# CITY OF CONWAY, ARKANSAS HISTORIC DISTRICT COMMISSION

June 23, 2025 • 5:30pm • 1111 Main Street

- A. Renovation & New Construction at 931 Faulkner St (HDR-0425-0054)-OLD BUSINESS
- B. Tree Removal at 2003 & 2005 Caldwell St (HDR-0625-0075)

**Address.** 931 Faulkner St - c.1935 (Plain-Traditional/Craftsman/Colonial Revival; Contributing).

East Elevation

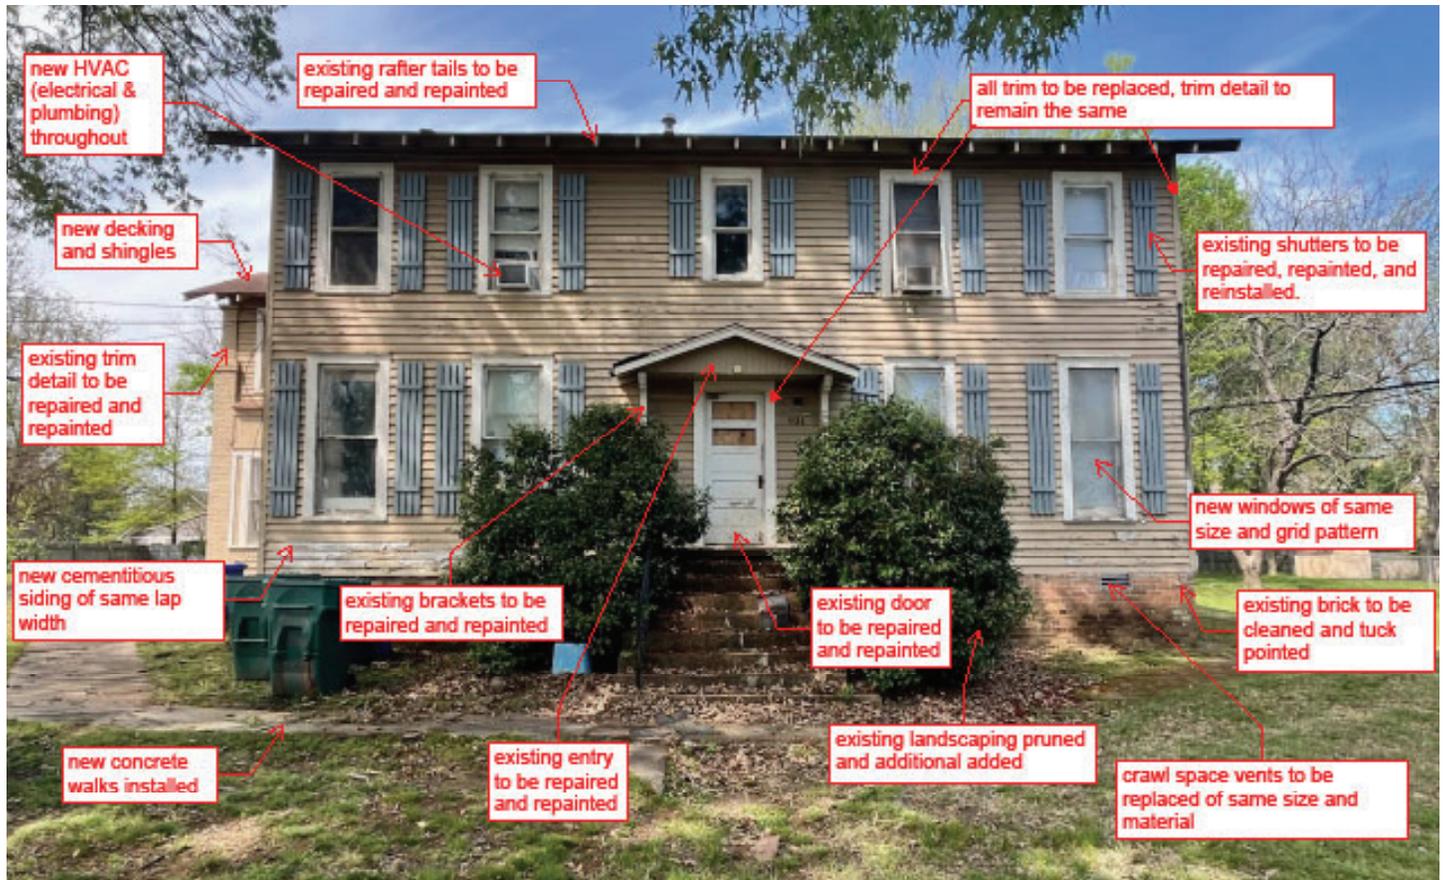
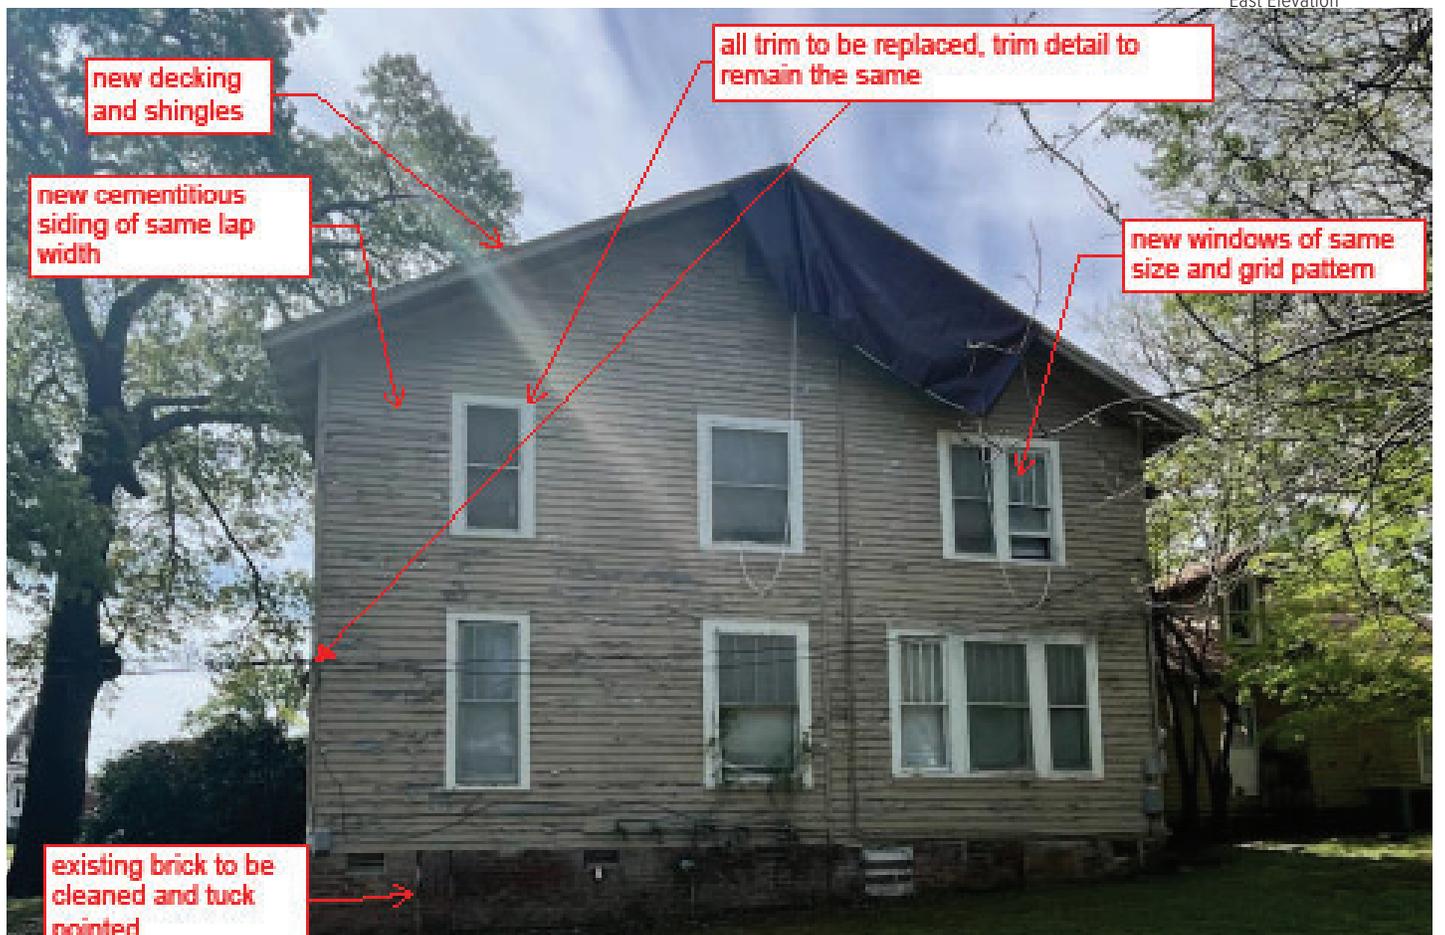
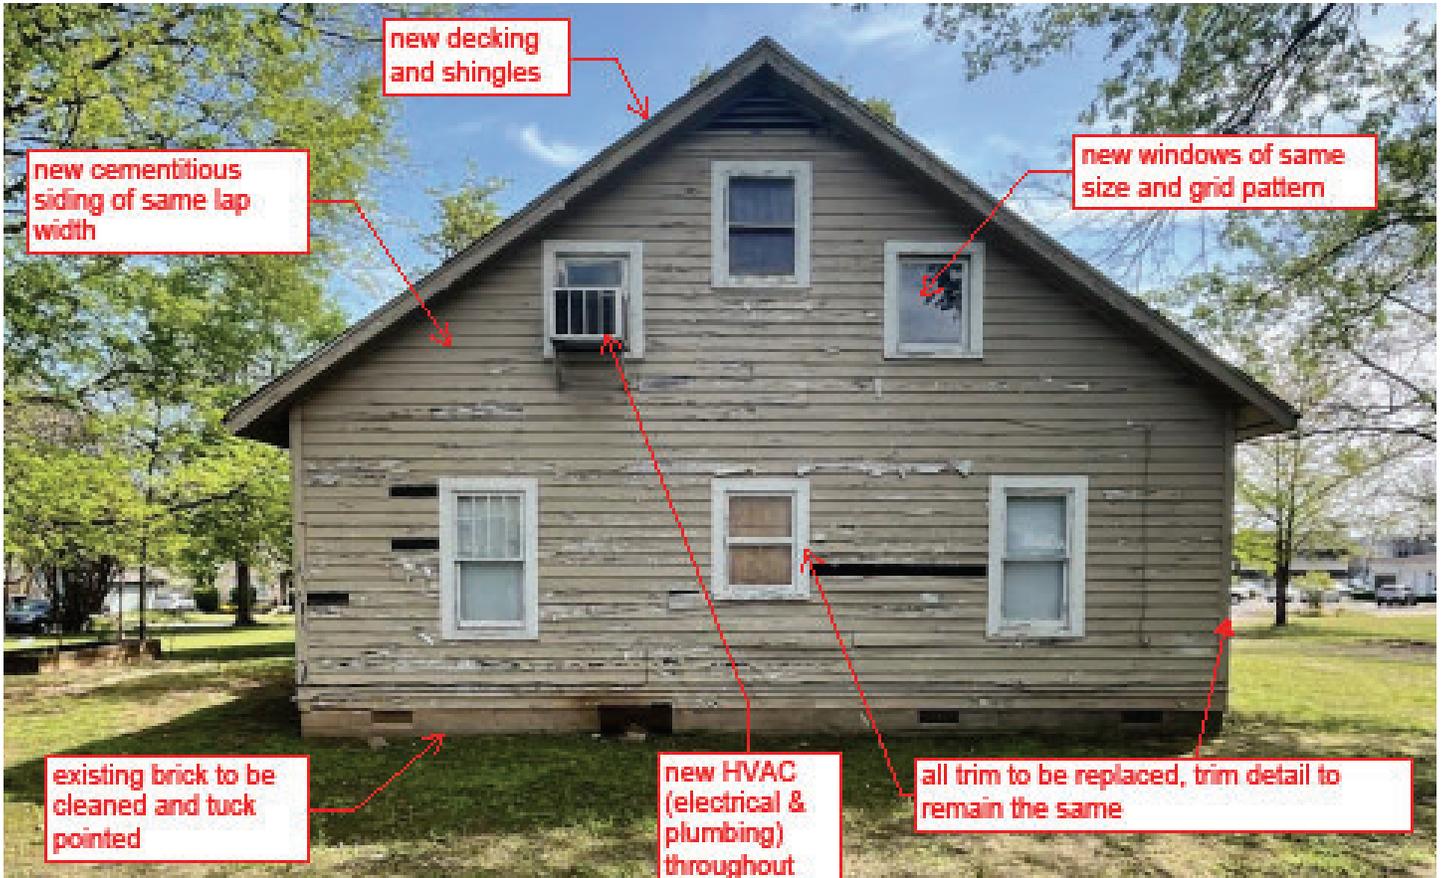
new HVAC (electrical & plumbing) throughout

existing rafter tails to be repaired and repainted

all trim to be replaced, trim detail to remain the same

new decking and shingles

existing shutters to be repaired, repainted, and reinstalled.

existing trim detail to be repaired and repainted

new windows of same size and grid pattern

new cementitious siding of same lap width

existing brackets to be repaired and repainted

existing door to be repaired and repainted

existing brick to be cleaned and tuck pointed

new concrete walks installed

existing entry to be repaired and repainted

existing landscaping pruned and additional added

crawl space vents to be replaced of same size and material

FRONT ELEVATION  
1/8" = 1'-0"

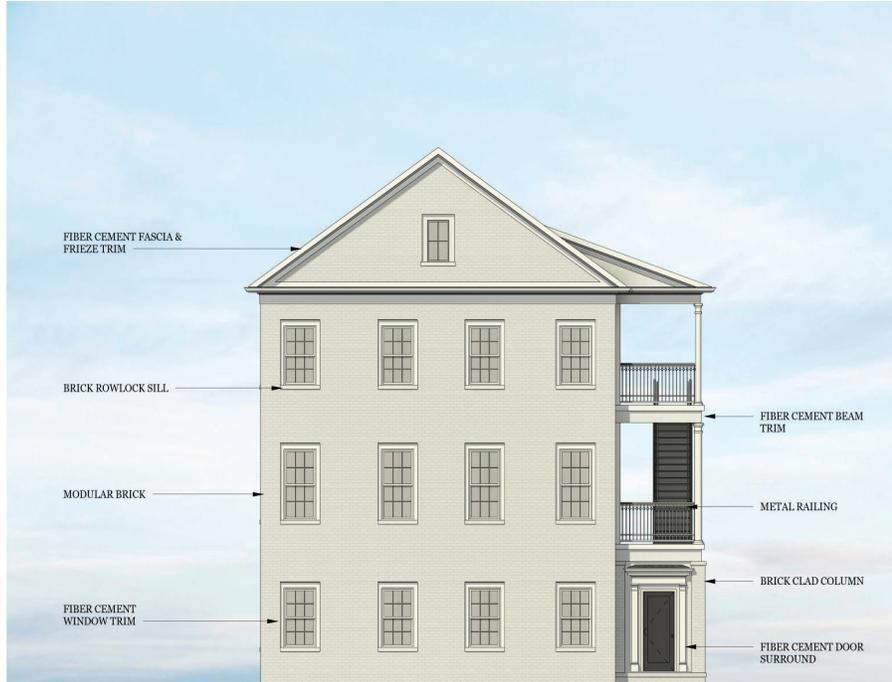
*The proposed dwelling will be oriented towards a shared courtyard on 931 Faulkner and will be aligned with the existing structure. The front elevation may benefit from additional architectural details which would help it visually align with the Faulkner facades of adjacent buildings. This could be in the form of larger bottom floor windows, planter boxes, differing materials/textures, etc. The front door could be more pronounced to mitigate the orientation discrepancy. More details on other elevations should be considered, especially the southern elevation which is visible for northbound traffic on Faulkner St. It is the project architect's assertion that the simplicity of the eastern and southern façade are integral to the style and embellishments are not necessary. Staff does not find this claim to be in conflict with the regulations or guidelines.*

**Windows.** Select windows and doors for proposed new buildings that are compatible in material, subdivision, proportion, pattern, and detail with the windows and doors of surrounding buildings.  
*The applicant is proposing six over six windows with fiber cement trim which appears comparable to the trim width of adjacent structures of a similar style. Dormers may be considered for the attic windows.*

6. ~~If shutters are to remain, they shall be replaced with a functional equivalent sized to fit the window openings.~~
7. ~~Prior to issuance of a Certificate of Appropriateness, applicant shall provide planning staff with:~~

- ~~Elevations that mitigate the new construction's orientation discrepancy on the Faulkner St façade.~~

- Additional architectural details on the Southern elevation.
  - Courtyard-entrance details (i.e. fencing type, vegetation, etc.):
8. Roofing shall be asphalt or composition type shingles.

- A NINE ONE - BEDROOM APARTM
- B PRIVATE COURTYARD
- C EXISTING BUILDING
- D PARKING COURT

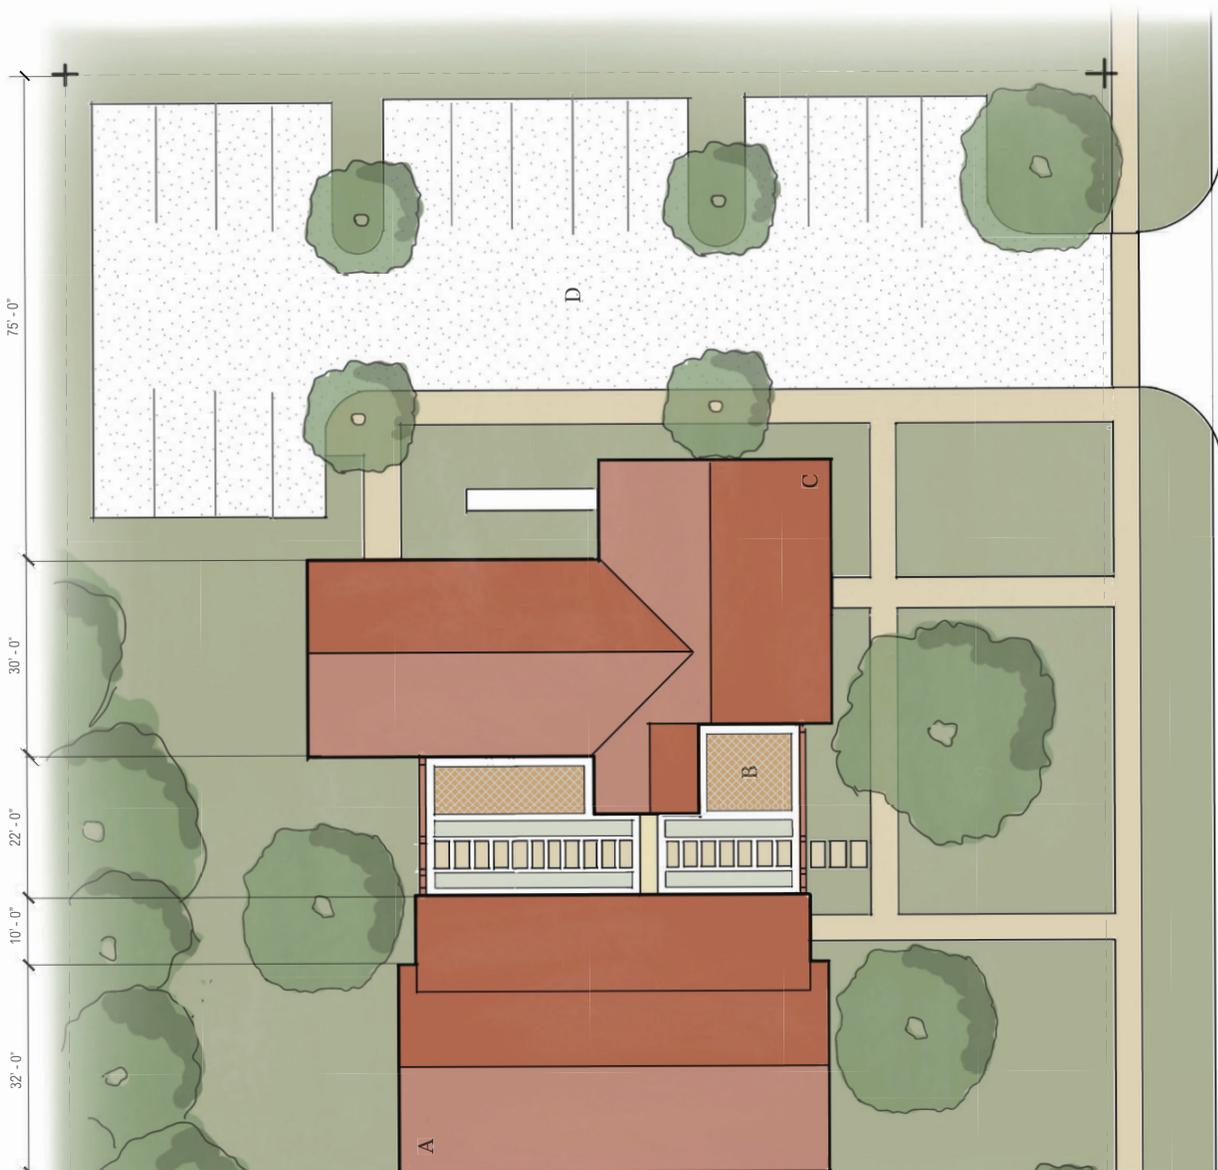
*Parking is proposed to the north side of the development. The parking lot will be landscaped.*

*Some of the existing walkways will be repaired. Additional walkways are proposed. One driveway encroachment is proposed that leads to a proposed seventeen (17) spot parking area. The location of the parking area will necessitate the removal of six (6) significant trees. The parking lot is on the north side of the property. A parking lot at the rear would disturb the buffer between the dwellings and adjacent property, including the removal of trees at the rear of the property. The rear setback between the existing dwelling and the rear property line is approximately 30' which is insufficient for a parking area.*

*The proposed driveway and parking area must conform. The existing Southern driveway area should be removed.*

3. Driveway and parking shall be composed of brick, stone, pavers, or concrete. Asphalt is not permitted.
4. Masonry shall be cleaned with the gentlest means (water blasting is not permitted). The brick shall not be painted.

15. The property shall be replanted prior to, or concurrently with, Site Development Review.
  16. Existing driveway shall be removed.

BRUCE STREET R/W  
 REPLAT LOT II BLOCK 7  
 DAVIES AND GARVINS ANNEX

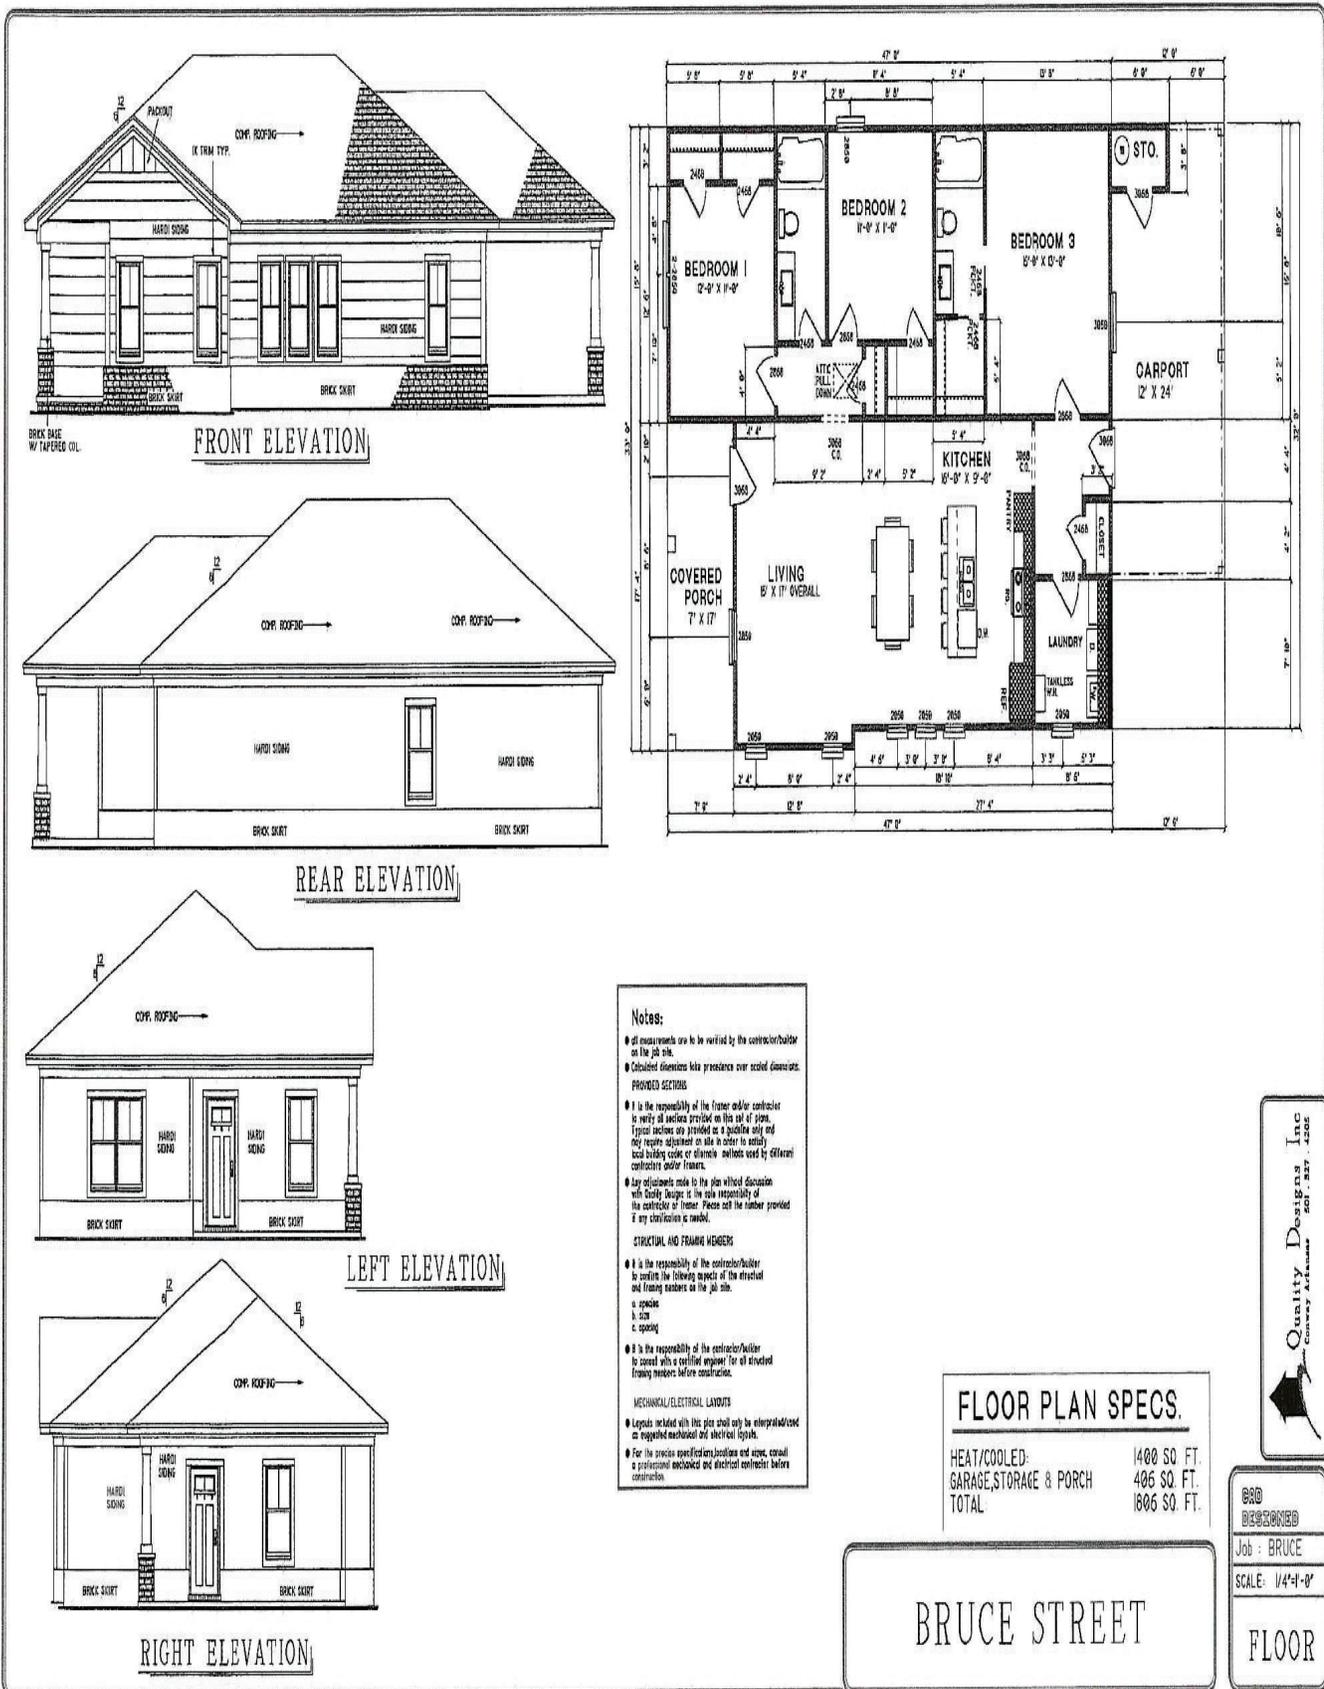
*The applicant has indicated a driveway off Bruce St. It appears to be concrete and 12' wide. It is located at the western side of the residence. Parking will be accommodated by a carport at the termination of the driveway.*

*No sidewalk is proposed. The project triggers a new sidewalk along Bruce St. Bruce St is a residential collector which requires 5' sidewalks with 7' greenspace area. Sidewalk construction notes on Plat of Record state: "Sidewalks along residential streets: Sidewalks along streets with residential lots shall be constructed by the homeowner/builder. The sidewalk shall be installed prior to the final inspection and issuance of a Certificate of Occupancy."*

*The applicant has indicated the removal of one canopy tree to accommodate the proposed carport. To adhere to the above tree-to- frontage ratio, it is recommended that an additional canopy tree be planted. An understory tree would suffice.*

2. One tree from the approved tree species list shall be planted along the Bruce St frontage (outside of right-of-way).
  3. Driveway shall be concrete, pavers, a ribbon or permeable paving. A ribbon driveway is encouraged.

4. Prior to issuance of a Certificate of Occupancy, a 5' sidewalk with 7' greenspace shall be installed.
  5. Lighting shall be downward and inward toward the property.
